ADDENDUM NO. 7

DATE: April 20, 2020

PROJECT: ITB 20343
BETHUNE POINT WATER RECLAMATION FACILITY
GENERATOR REPLACEMENT

PHASE 2 DEMOLITION SINGLE LINE
 NO SCALE

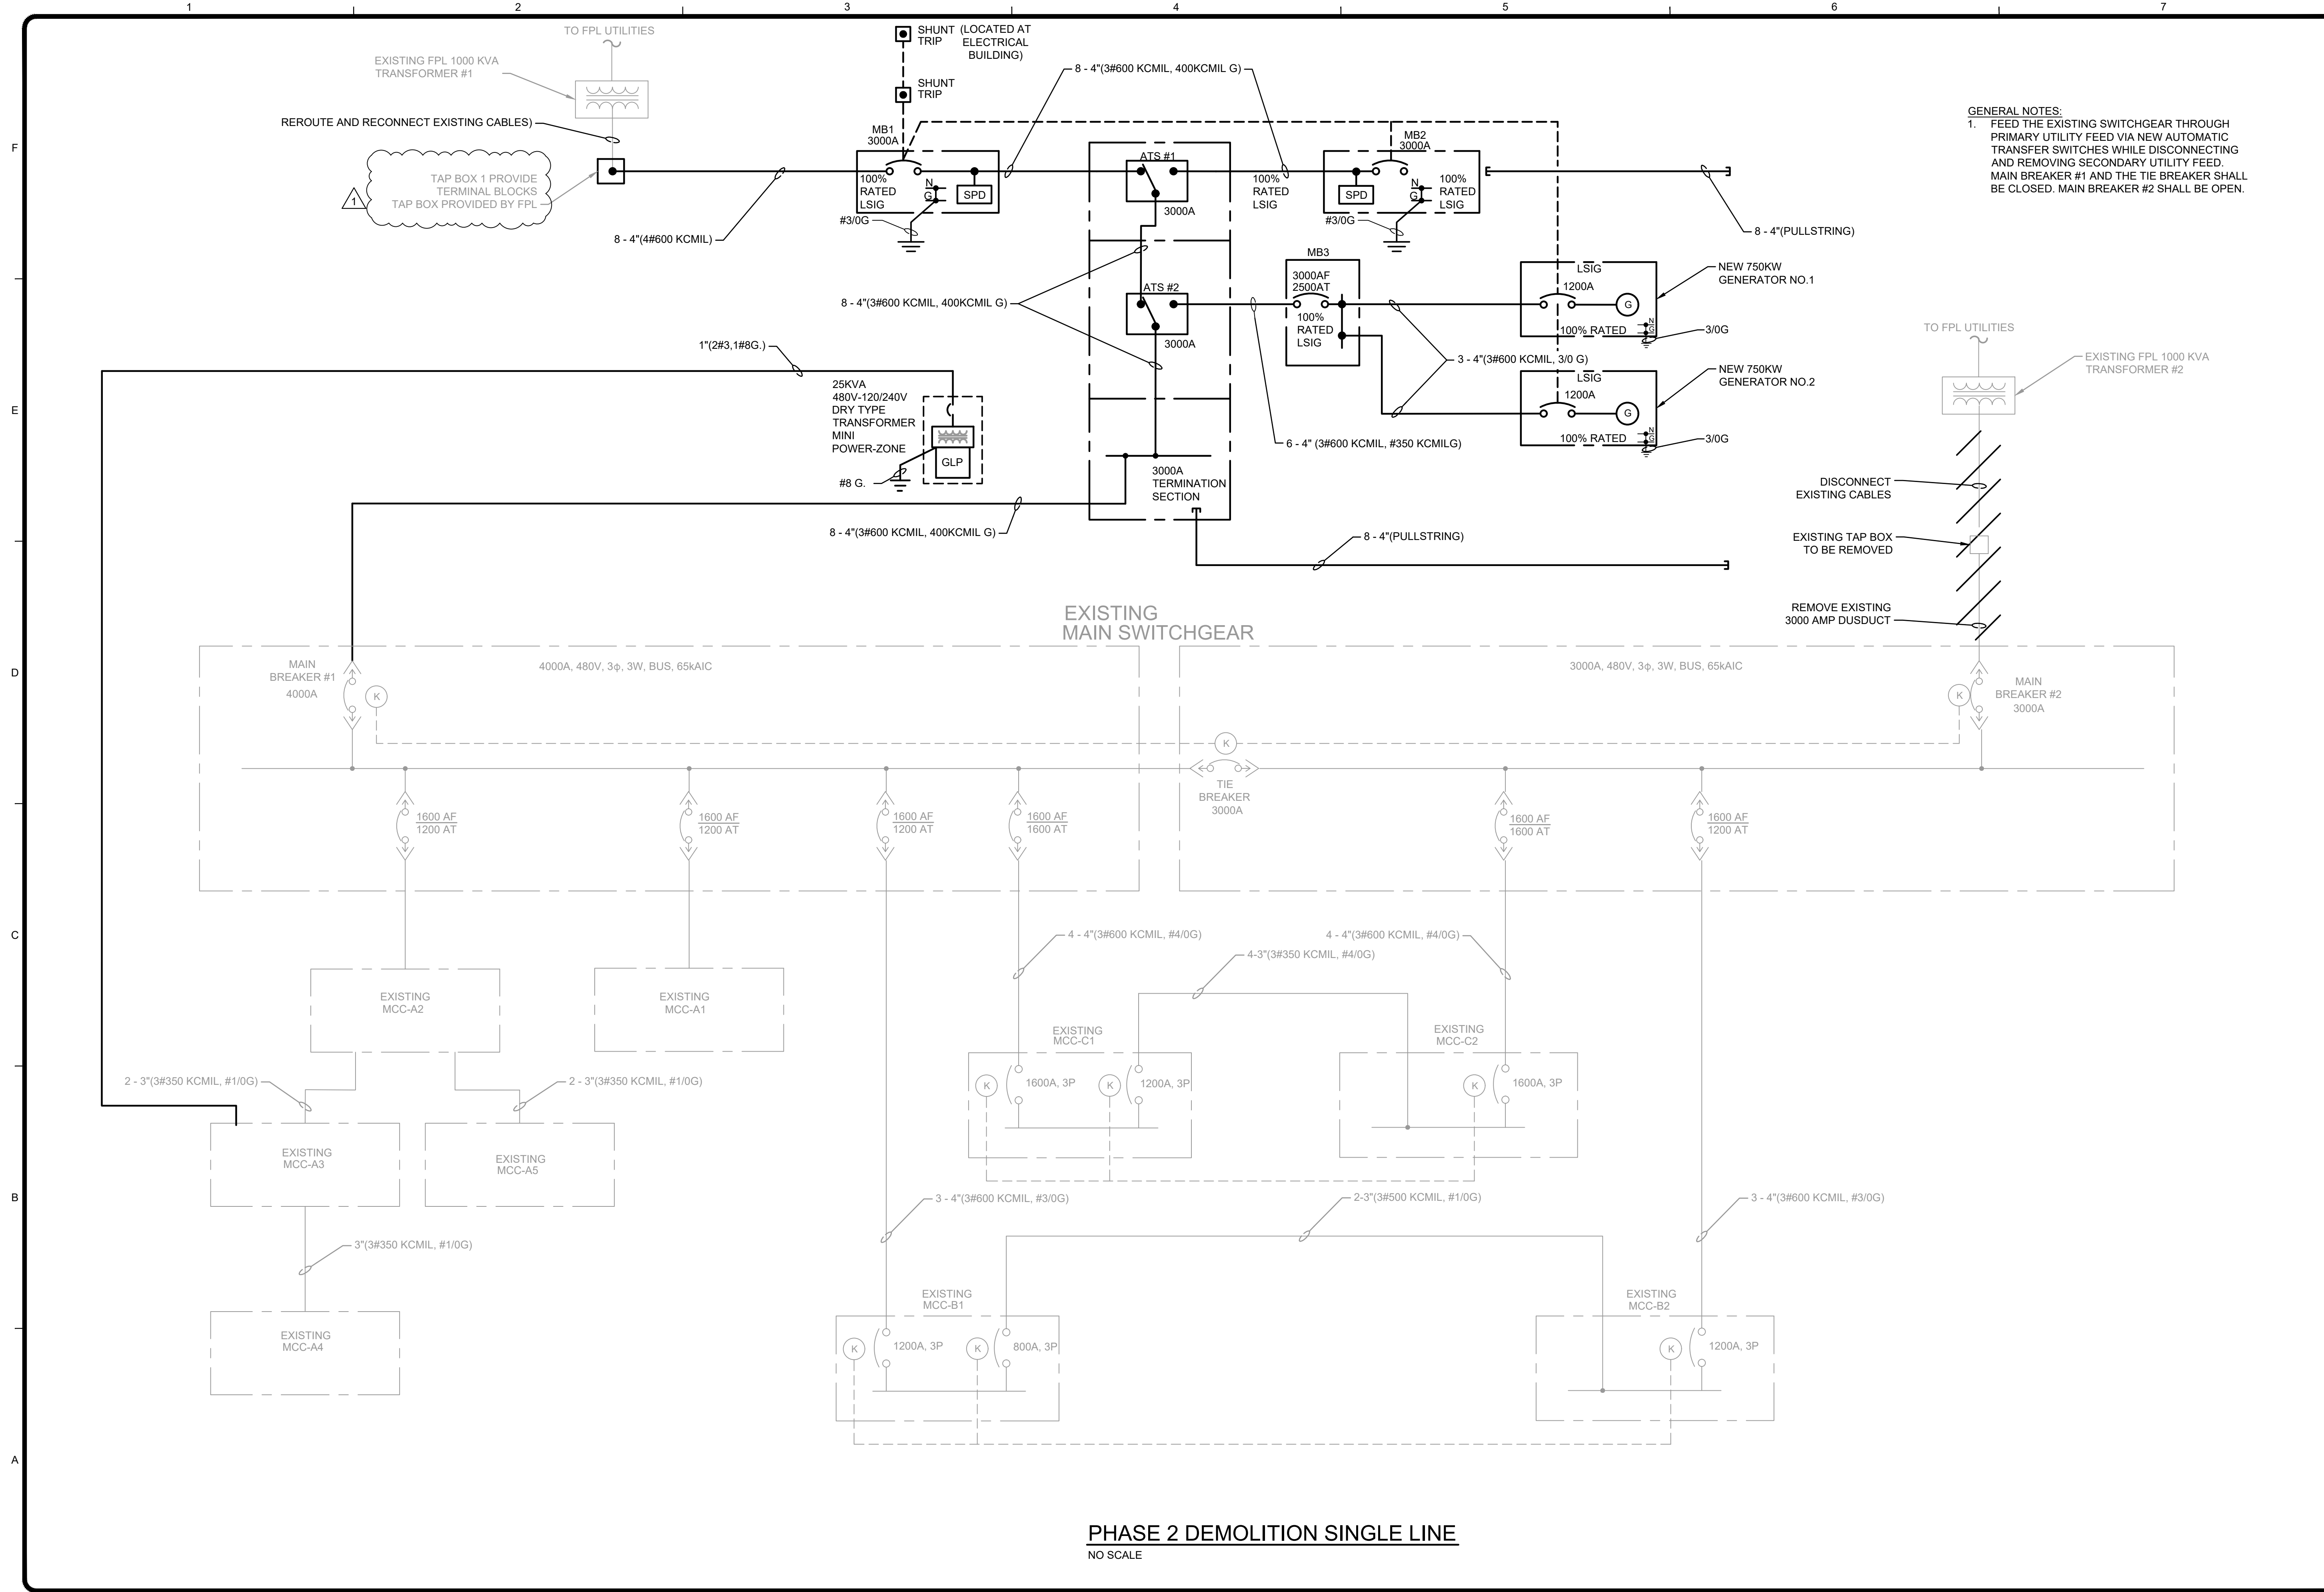
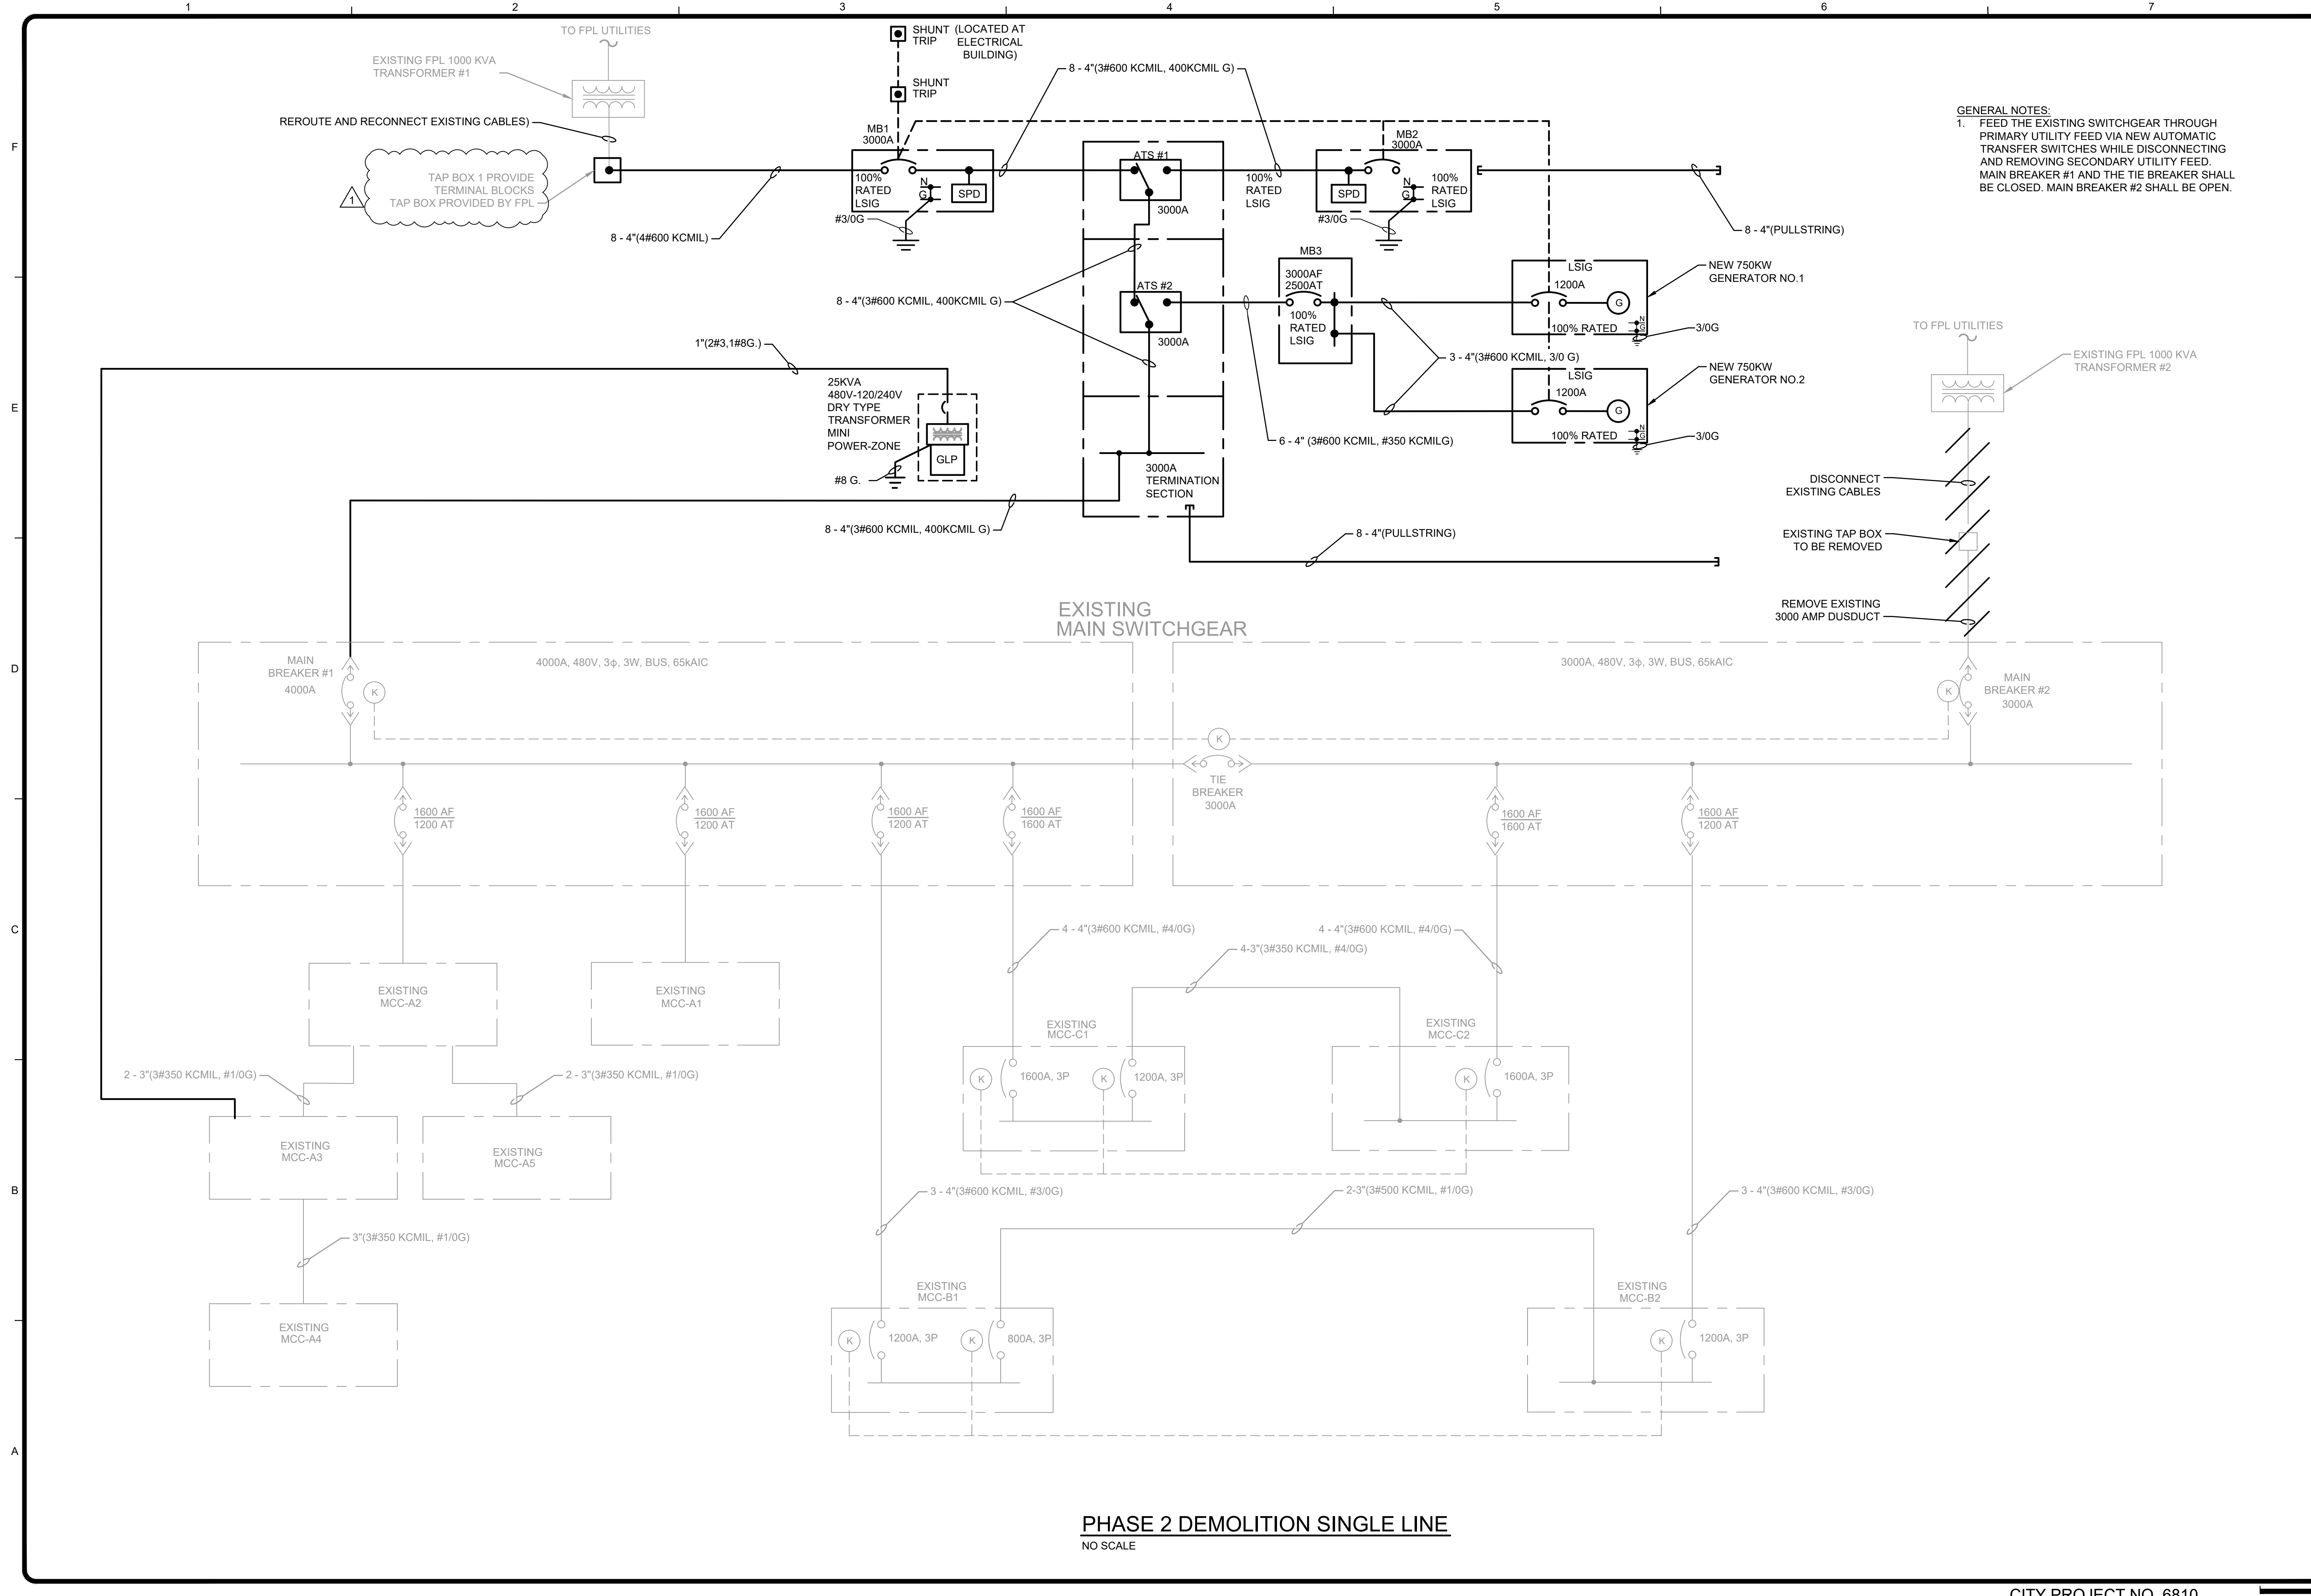
Q27: Please provide specifications for the two new Tap Boxes that will be furnished and installed in the existing FPL vault.

A27: Tap boxes to be provided by FPL. Contractor to coordinate. See changes to sheets E-102, E-603, E-604.

ELECTRICAL PLAN
SCALE: 1/4" = 1' - 0"

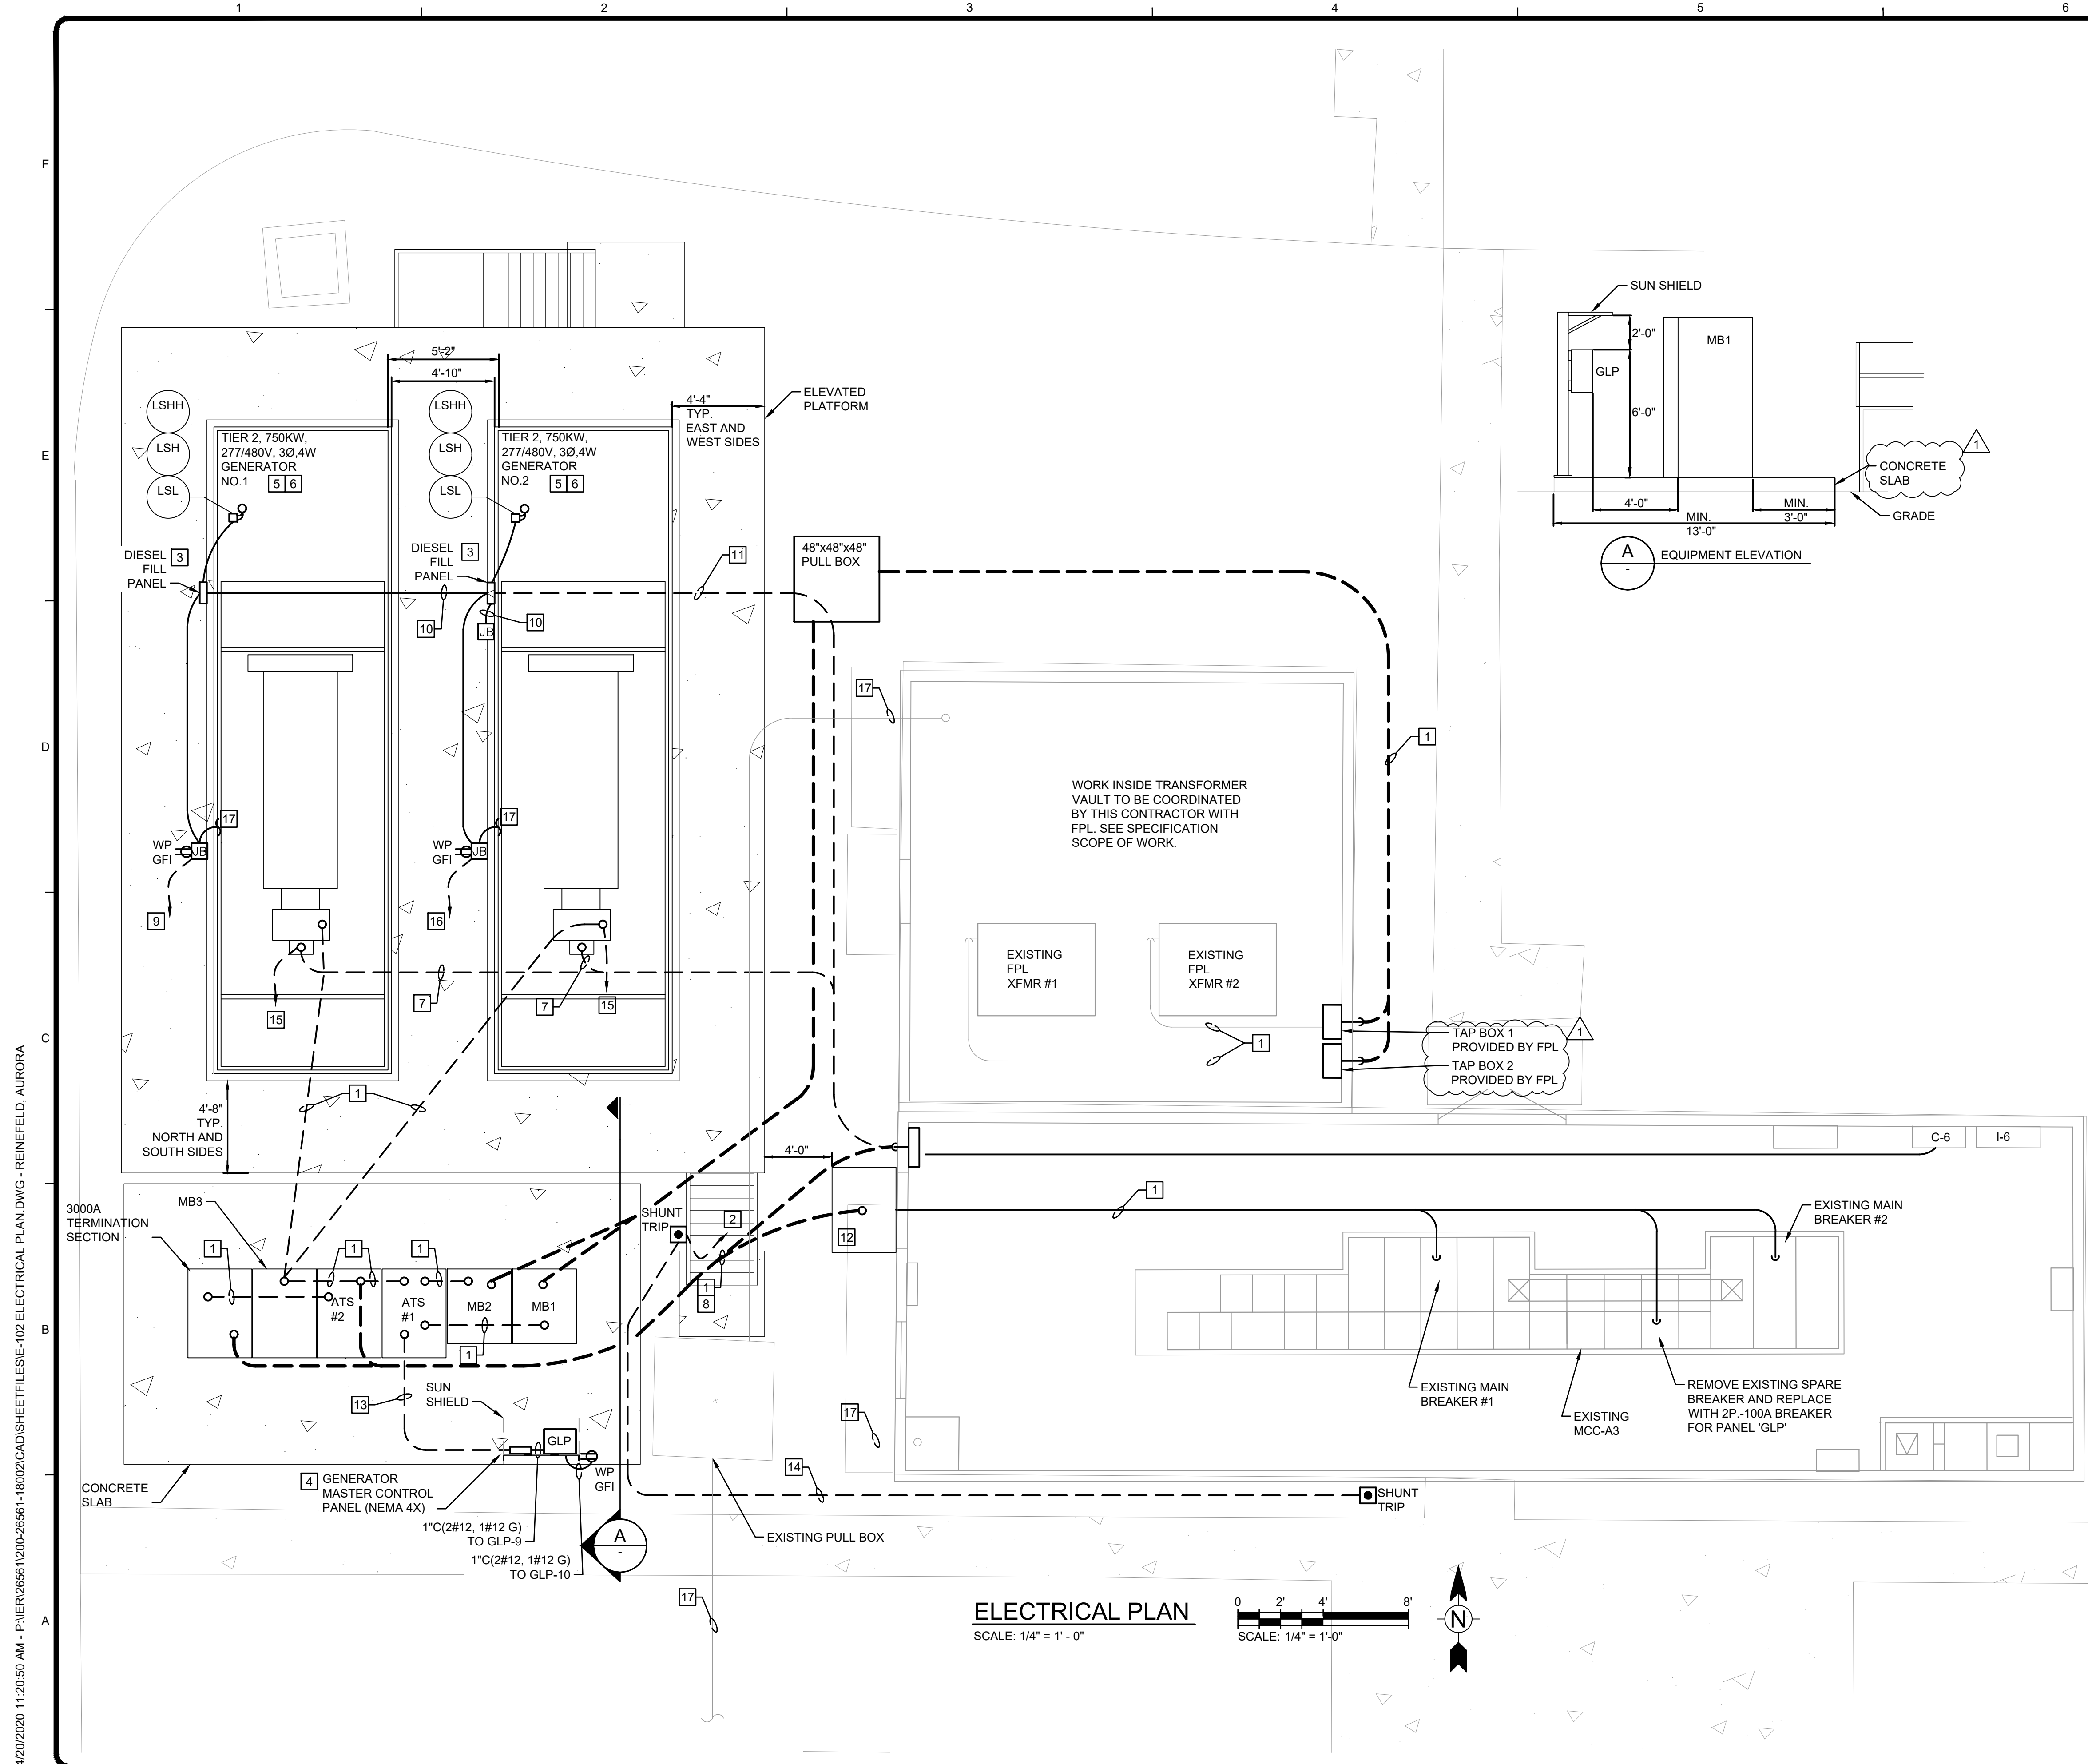
Q3: 5/E-502 shows aluminum equipment racks with stainless steel hardware. This detail is not referenced on any other drawing. Please provide additional detail on where equipment racks are to be located.

Q14: Drawing E-102 shows a note tag "17" however there is no description for Note 17 shown on the drawing. Please provide a description for Note 17.

A3: Panel GLP and Generator Master Control Panel shown on sheet E-102 will be rack mounted.

A14: Note 17 shall be "1"C (4#12, 2#6, 1#10G) FROM JUNCTION BOX TO BATTERY CHARGER, JACKET WATER HEATER, LIGHTS AND MISC."
